RE: Evans Coal Corporation
KY0107322
NOD Dated 09/08/08

EVANS COAL CORP.
 PERMIT NO. 861-5340
 SEDCAD SUBWATERSHED MAP

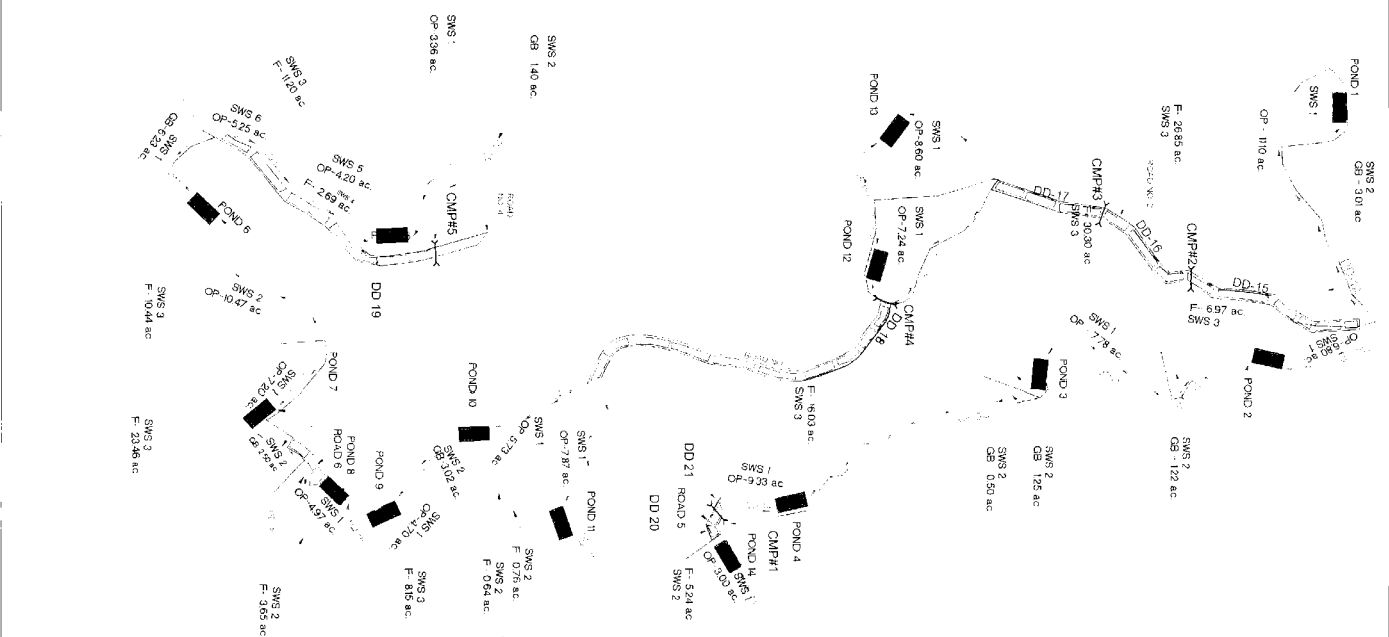
•KPDES Form 1, Item 2, II

This is a surface mining operation and outfall is precipitation dependent. I have included a drawing depicting the sediment structures, the watershed areas contributing flow to each discharge and water flow via diversion ditches directed to these ponds.
